Reviewer 1

The comments of Reviewer 1, along with our responses to each comment, are included below:

“This work presents a boundary optimal control strategy for axial tubular reactors with first-order irreversible chemical reaction incorporating a delayed recycle stream. The mathematical description takes the form of a system of coupled parabolic and hyperbolic PDEs. An infinite-dimensional approach is applied to derive a linear quadratic regulator with and without observer. Numerical studies show that the proposed controller is able to stabilize the system. The manuscript is clear and well written and addresses a challenging control problem in chemical engineering. The following comments and suggestions may improve the presentation so that it is considered for publication.”

Figure 1: Concentration profile along the recycle stream

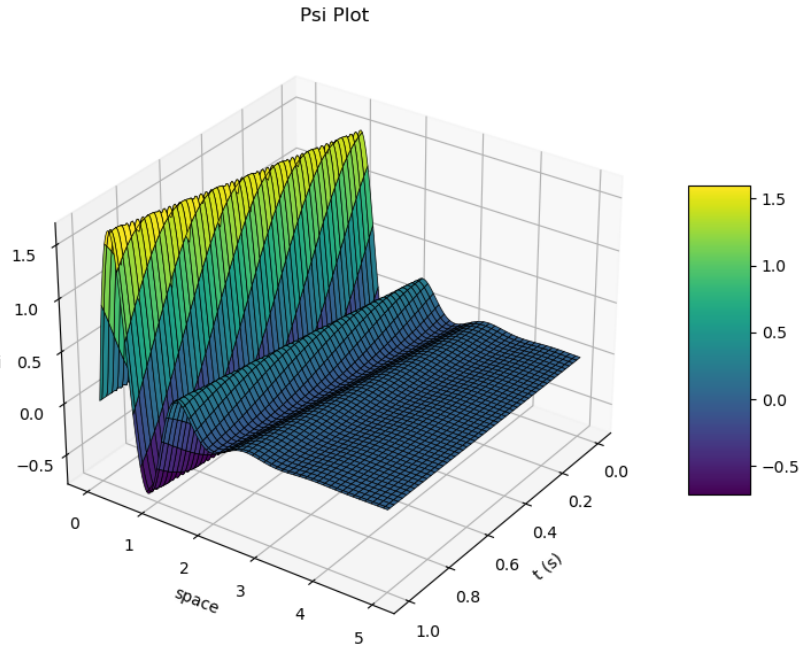
6. Page 7 - " $x_2(\zeta, t)$ is introduced as a new state variable to account for the concentration along the recycle stream"

- Why is x_2 a function of ζ ? How does x_2 change across the recycle? What kind of law does it follow? To me, it seems like x_2 only changes with respect to time

We have assumed that along the recycle stream, the flow of the reactant belongs to the class of pure transport PDEs. This is the case when diffusion term and reaction term become negligible compared to the convective term, and the state variable x_2 is merely being transported along the recycle stream. Nevertheless, this still means that x_2 is a function of ζ and t . Concentration profile along the recycle stream has not been presented in the original submission as we believe it is not the focus of this work. However, for the reviewer's reference, it is included here in the response as

shown in Fig. 1.

Figure 2: Axial tubular reactor with recycle stream.

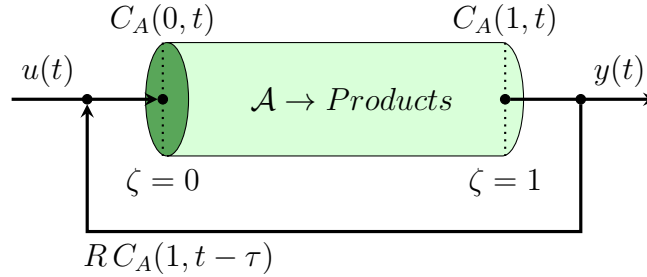
11. Page 18 - unstable dynamics of the model

- Why is the zero-input response considered unstable? Is it a qualitative assessment? What is the physical meaning of Figure 9?

For the axial dispersion tubular reactor presented in Fig. 2, the molar balance equation may be written for the reactant concentration, C_A , as follows:

As a result, the zero-input response is considered unstable due to the positive reaction term in the model. Figure 9 illustrates the unstable dynamics of the linearized model in the vicinity of the steady-state in the absence of control input; with the qualitative assessment that a deviation from the steady state may draw the system to a different steady state, resulting in completely different model dynamics than the one used to design and control the system for optimal operation. The manuscript has been updated to include more detailed explanation in this regard.
